**RESOLUTION 2022-12-07**

**A RESOLUTION OF THE DOWNTOWN INVESTMENT AUTHORITY (“DIA”) APPROVING WITH CONDITIONS THE SITE PLAN FOR THE MUSEUM PARCEL, AS SHOWN IN EXHIBIT ‘A’; PROVIDING THE DIA CHIEF EXECUTIVE OFFICER (“CEO”) WITH THE AUTHORITY TO ADMINISTRATIVELY APPROVE MINOR CHANGES TO THE LOCATIONS OF ENTRANCES AND EXITS, BUILDING DIMENSIONS, AND USES AND ENGAGEMENT OF THE MUSEUM PARCEL ON BAY STREET AND THE RIVERFRONT; PROVIDING GUIDANCE TO THE DOWNTOWN DEVELOPMENT REVIEW BOARD (“DDRB”) AS TO THE DIA’S EXPECTATION ON BUILDING DESIGN FEATURES, RELATIONSHIP TO THE PARTNERSHIP AND PARK PARCELS, AND ACTIVATION; AUTHORIZING THE CEO OF THE DIA TO TAKE ALL ACTION NECESSARY TO EFFECTUATE THE PURPOSES OF THIS RESOLUTION; PROVIDING FOR AN EFFECTIVE DATE.**

## MOSH GENESIS DIA CONCEPT REVIEW

# CONCEPT PLAN

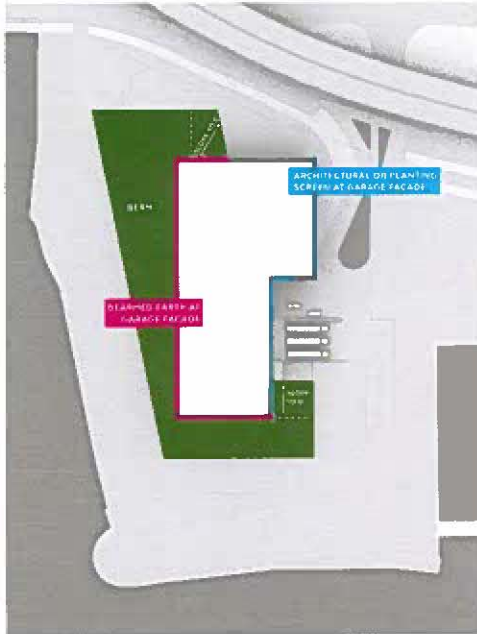
1. Building egress points to Bay Street and the St. Johns River shall be prominent and have a direct, external connection to each other with the intention that these access points ensure a strong relationship between the building and the site.

2. The museum's rooftop shall be activated consistent with the Downtown Zoning Overlay.
3. The Activity Node beacon shall be located along the St. Johns River frontage, at the south end of the property.

5. The Urban Open Space between the building and Bay Street shall feature public art or interactive equipment or installations (i.e., swings, exercise or play equipment, information kiosks, and/or similar features) for a curated pedestrian experience.

6. The continuous right-turn lane from Bay Street into the bus drop-off loop shall be removed. Entrance to the site shall be via A Philip Randolph Boulevard, however a right turn lane at the signalized intersection may be allowed subject to traffic Engineering approval.
